1 Products affected

2 Type of change

4758 Strip Block					0118.2242	
creation date	created by	release date	released by	notification no.	revision	page
2014-09-15	hotzar	2015-02-17	hotzar	27061	-	1 of 2

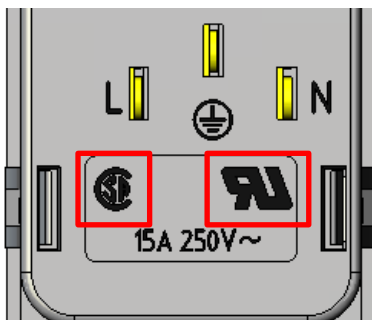
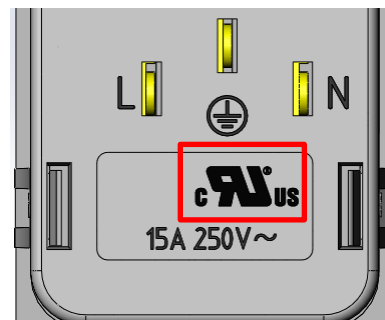
New combined cURus approval mark instead of separate UR and CSA marks.
 Slight modification on the lateral indentation.

Consolidation of North American approval marks with the combined cURus mark.
 Slight modification on the lateral indentation because of optimization of the injection process.

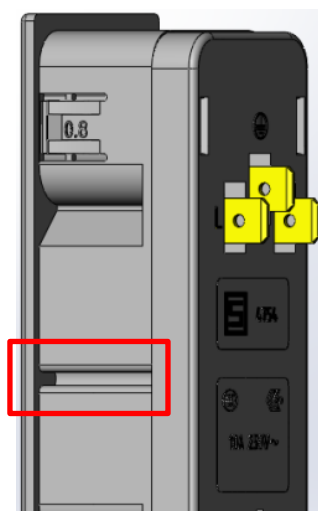
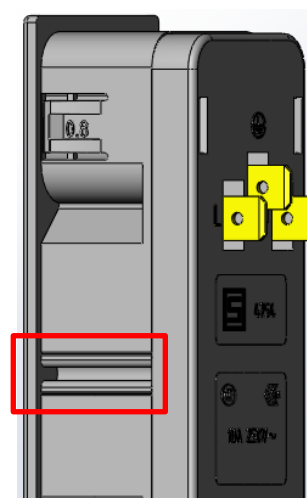
Modification of approval marks.
 Slight modification on the lateral indentation.

Form: Yes Socket has two slit on the both side
 Fit: No There are no dimensional changes
 Function: No No change on the specification
 Production Site: No There is no change of the production site
 Product Label: Yes CSA and UR replaced by cURus mark
